United States Department of the Interior

Re: Resource Recovery and Protection Plan Modification, 4 Right 4 East Longwall Panel, SUFCO Mine

4R4E PANEL -- DRILLING RESULTS		
SCALE: 1" = 600'	DATE: 10/13/2017	DRAWN BY: AMR
ENGINEER: AMR	CHECKED BY: JDS	PROJ:
FILE NAME: P:\00VT2017\BLM\diag\R2P2_MOD_4R4E.dwg

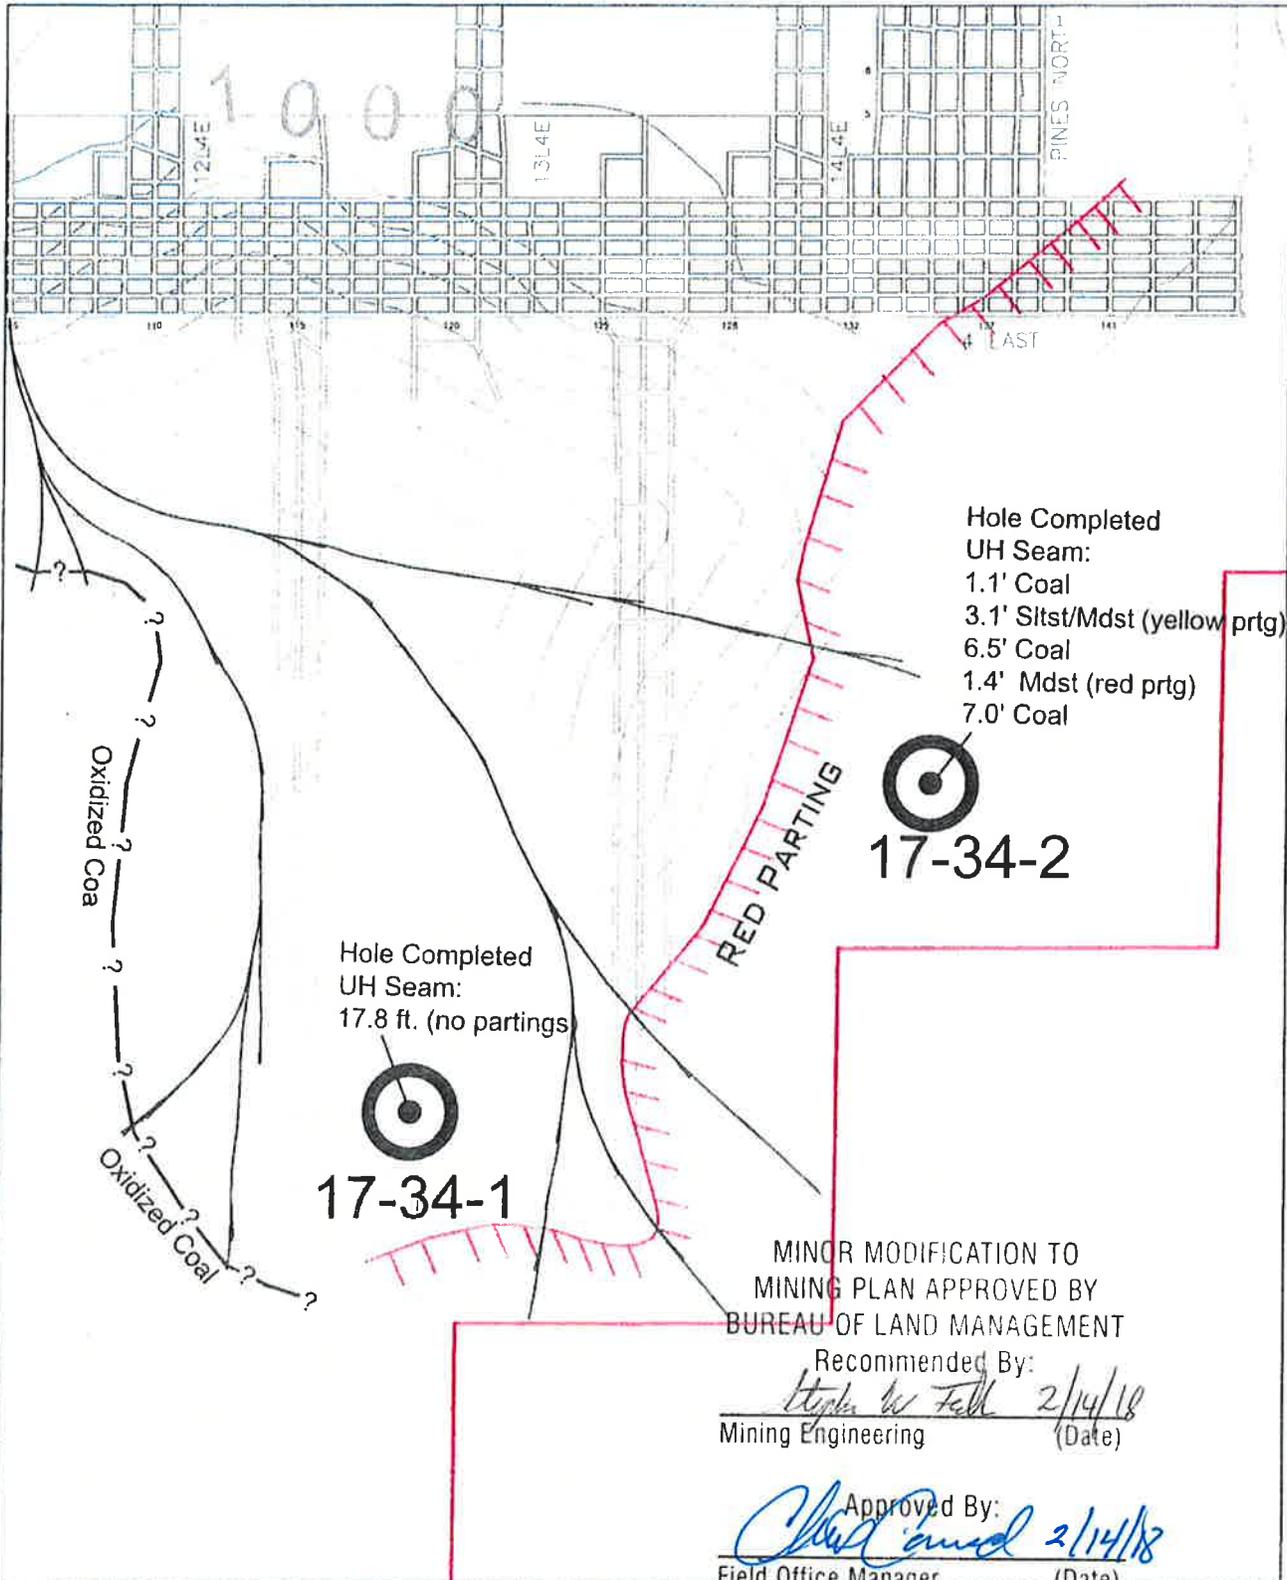
Background and Proposed Plan: Canyon Fuel proposes to mine a new longwall panel, 4R4E, that extends south off of the 4 East Mains. This block of coal was previously considered not mineable as a projected rock parting indicated thin coal in the area. Canyon Fuel has completed additional exploratory drilling, both surface and in-mine directional drilling, that has delineated a

block of coal of minable thickness for one projected longwall panel as depicted on the enclosed mine map.

Analysis of the Submission: The proposed longwall panel will mine underneath the Castlegate Sandstone escarpment and full longwall coal extraction may cause surface effects that falls under the jurisdiction of the Surface Mining Control and Reclamation Act (SMCRA), which governs all surface effects of underground coal mining operations. In addition, protection of certain resources from escarpment failure is also part of the lease stipulations and requires Forest Service concurrence to allow full extraction mining (longwall mining in this area) under an escarpment. So, before full extraction mining can begin, SMCRA permit approval must be given by Utah Division of Oil, Gas and Mining and the Forest Service must concur to meet the lease stipulation requirements.

We have received the Forest Service concurrence on January 24, 2018, a copy of this letter is enclosed. In their concurrence, the Forest Service found that no surface resources would be adversely impacted by this proposed permit and R2P2 change and thus it complies with the lease stipulations. With this concurrence, this R2P2 modification meets the requirements of the R2P2 under the Mineral Leasing Act (MLA), but SMCRA requirements need to be met in the mine permit from UDOGM. This letter will be copied to them (and the Manti-La Sal National Forest) and will be considered as BLM’s recommendation that longwall mining be authorized in the 4R4E longwall panel at the SUFCO Mine.

The FS has determined that no hazardous conditions will be created, as the location is relatively remote and generally inaccessible by the public. There are no structures at this location or within the path of potential escarpment failure or associated rock spalling downgradient. The North Fork of Quitchupah Creek and Dry Fork Creek are far below the location of the panel and are not anticipated to be impacted from escarpment failure or rock spalling. The FS has not identified any other surface resources that could be adversely impacted from escarpment failure or associated rock spalling.

Based on the review of the proposed permit amendment with respect to lease stipulation number 10, the FS concurs to the change in mining methods at this location from the originally permitted room and pillar mining to the 4 Right 4 East longwall panel.

we recommend that UDOGM approves this modification. You are authorized for any first mining (non-subsidence mining) but full extraction longwall mining will require UDOGM approval.
